ADDENDUM #1
WOLF VALLEY CONVENIENCE CENTER PROJECT
ANDERSON COUNTY, TENNESSEE
BID NUMBER 2206
RGC Project Number 20702
Issued August 27, 2021 for Bid on September 2, 2021

The purpose of the subject Addendum No. 1 is to make certain changes and clarifications in the Specifications and Bidding Documents for the above referenced project, and to answer questions that have been asked.

ANDERSON COUNTY SOLID WASTE
WOLF VALLEY ROAD CONVENIENCE CENTER

SWPPP - STAGE 2 - GRADING PLAN
EROSION & SEDIMENT CONTROL PLAN

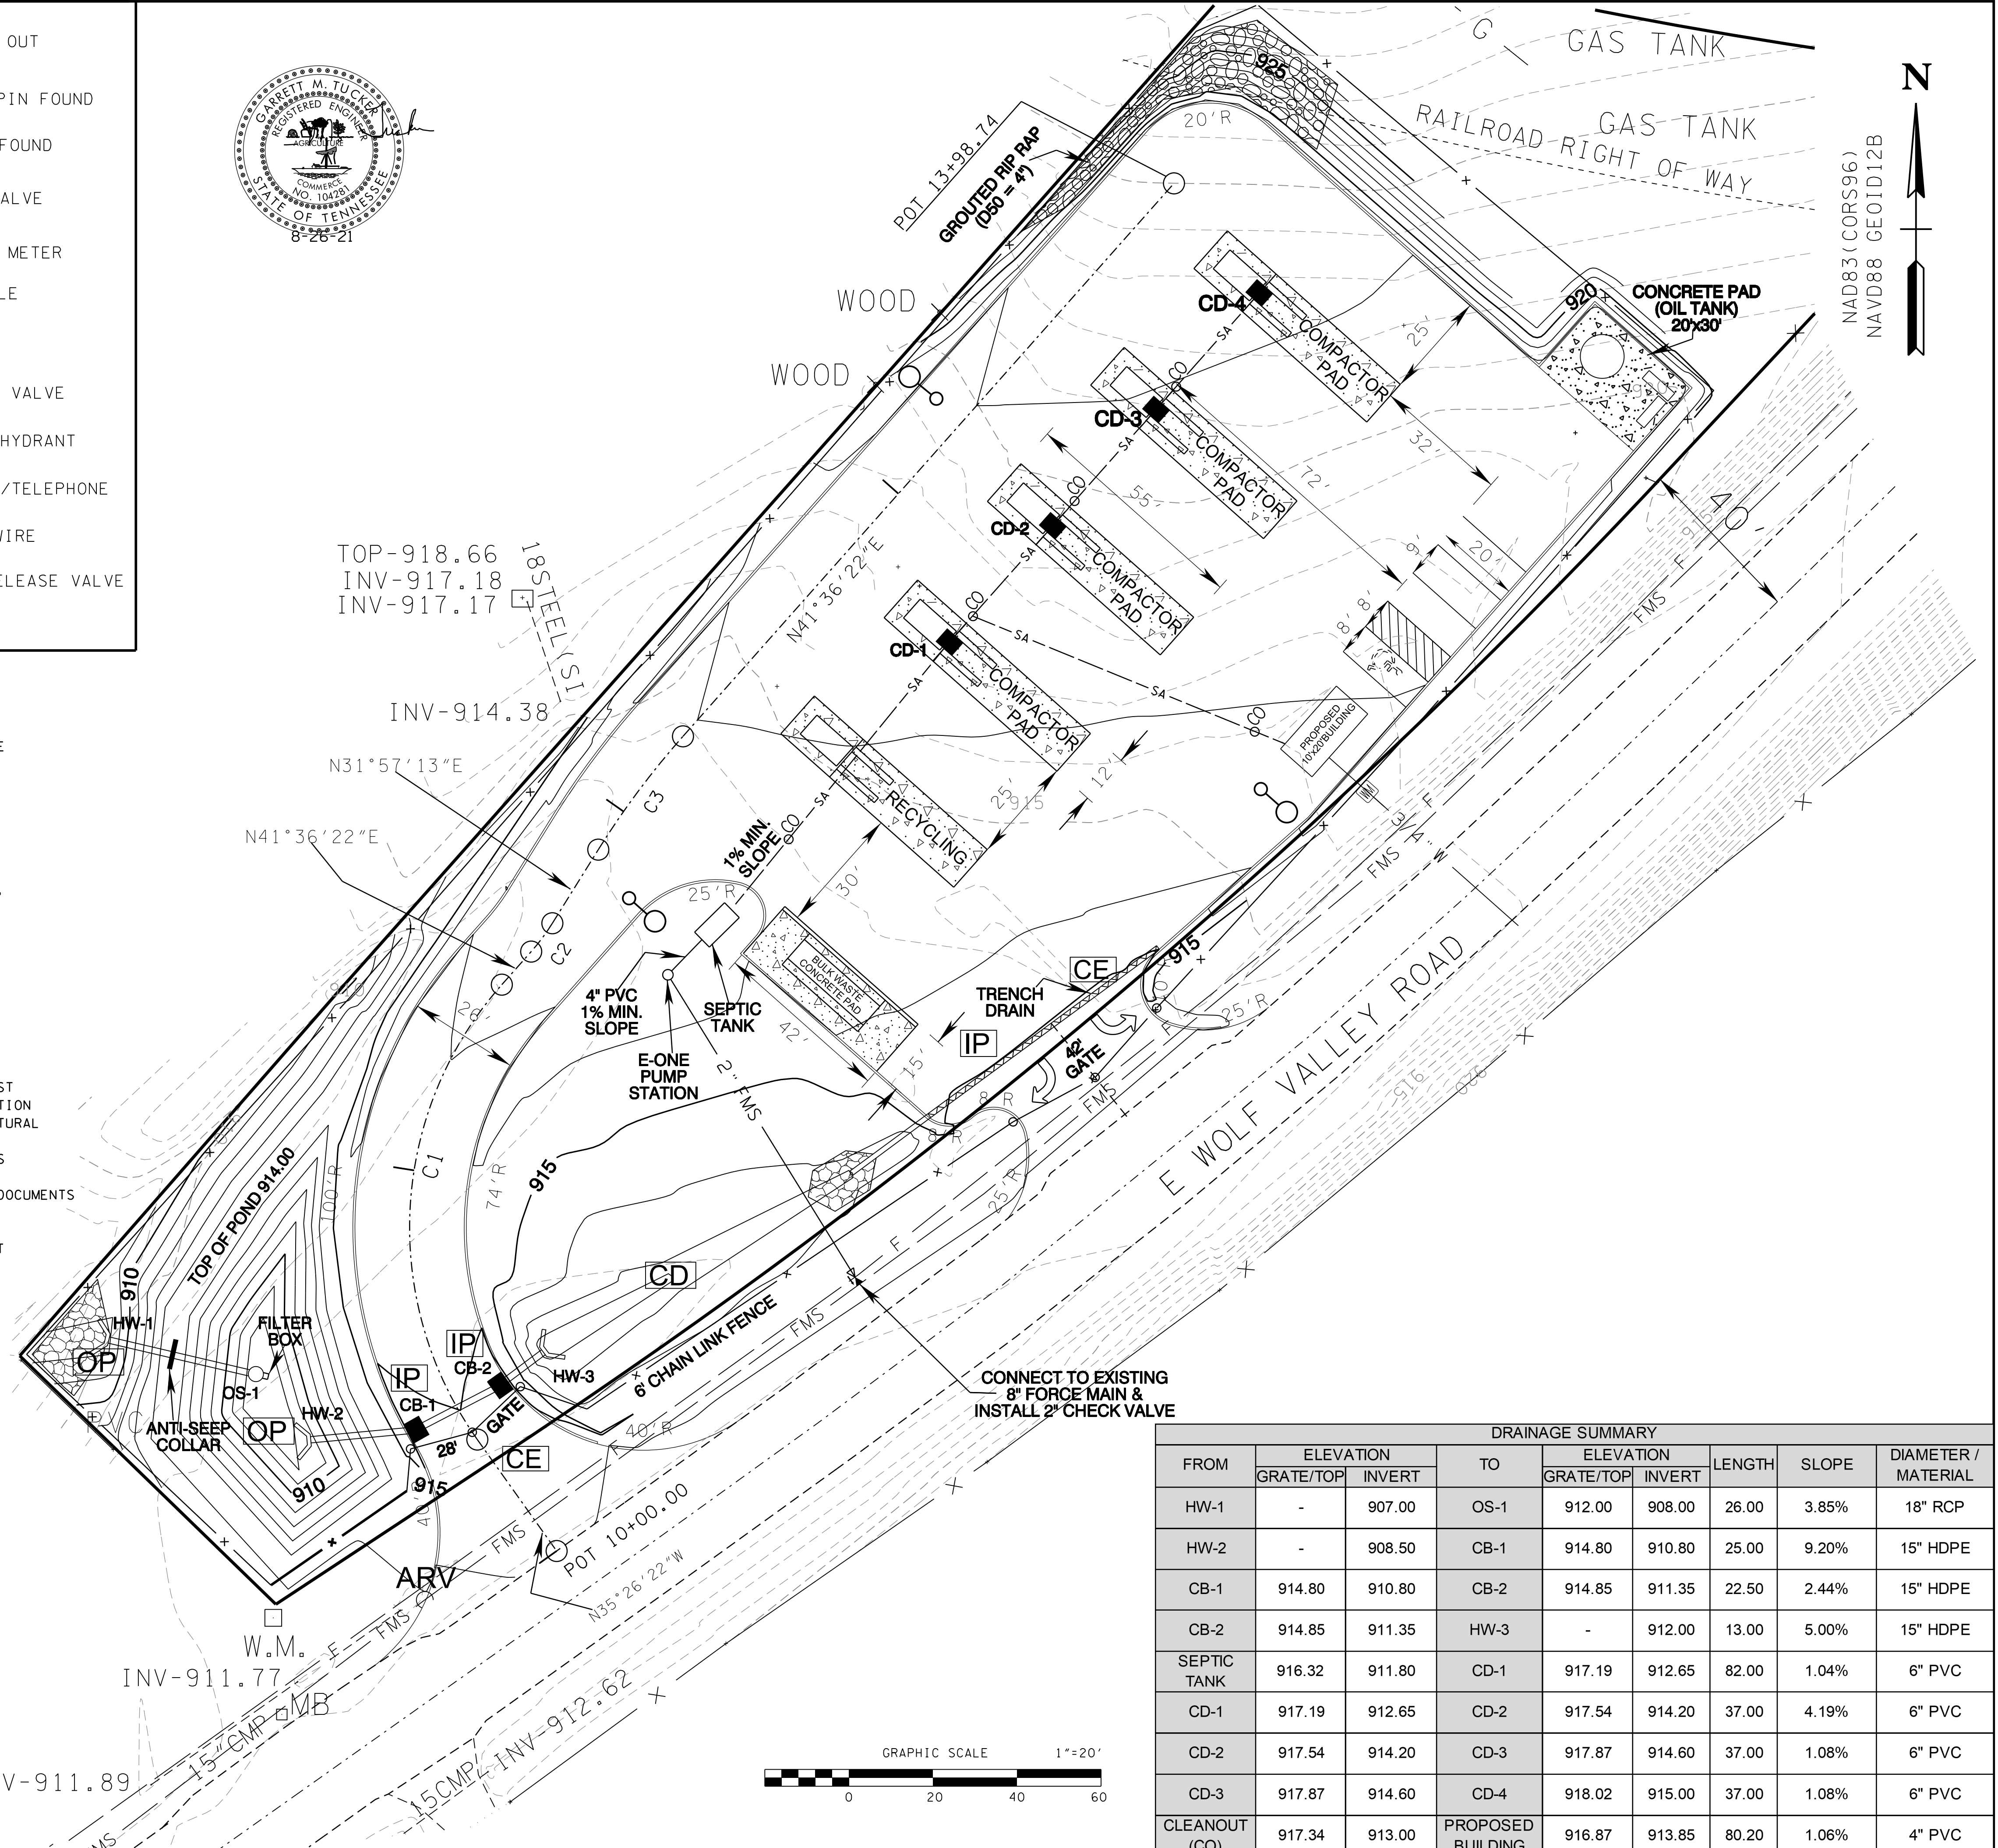
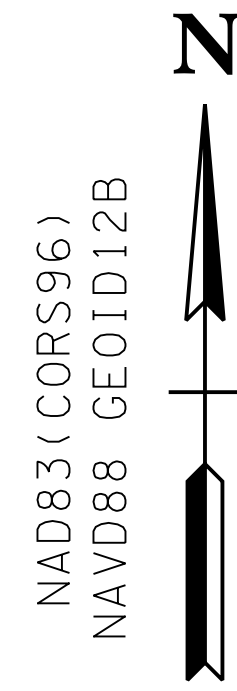
- 1) Sheet 4 (Revised water service)
- 2) Sheet 5 (Revised water service)
- 3) Sheet 10 (Revised pump details)
- 4) Sheet 11 (Removed backflow Preventer)

10. Will the existing water service be used for the control building? ***CUB will provide a tap on the existing 6" line across the road and install new 3/4" service line and meter assembly. A cost of \$3,500 is to be included in the bid price.***

TYPICAL CONCRETE MIX

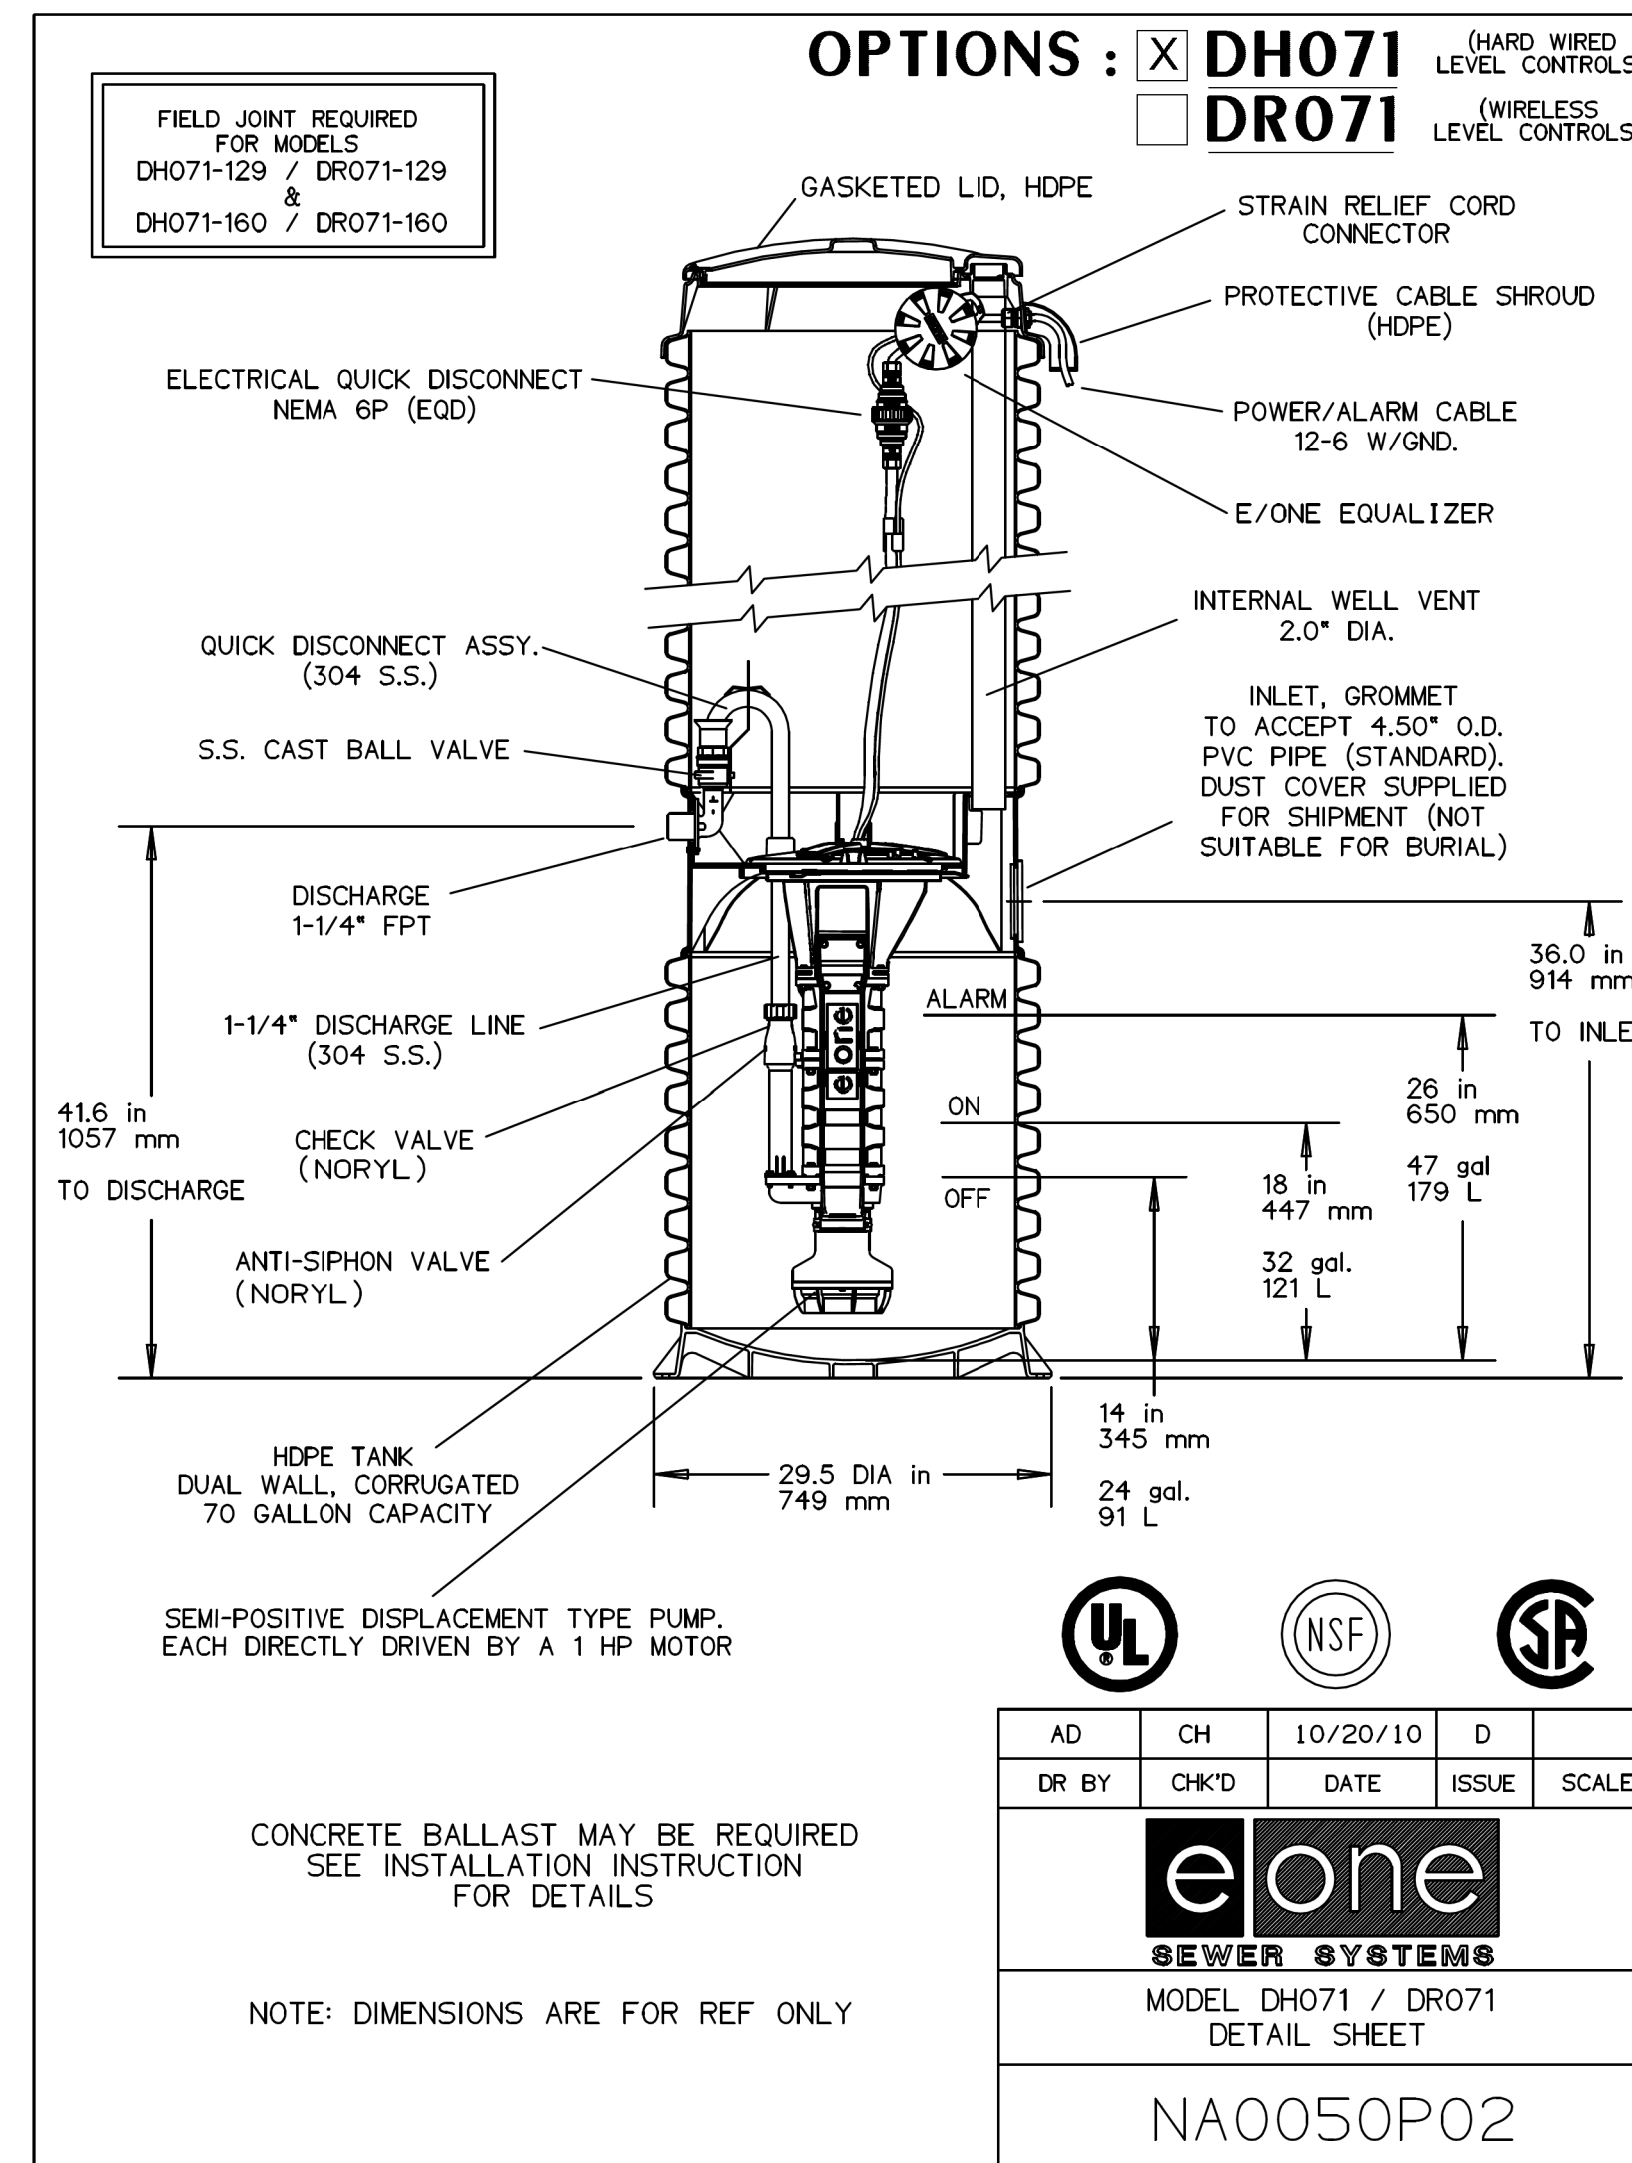
13. Concrete Suppliers are asking for a design of the concrete mix? ***A typical mix design has been provided on revised Sheet 10. Shop drawing approval will be required for concrete and rebar.***
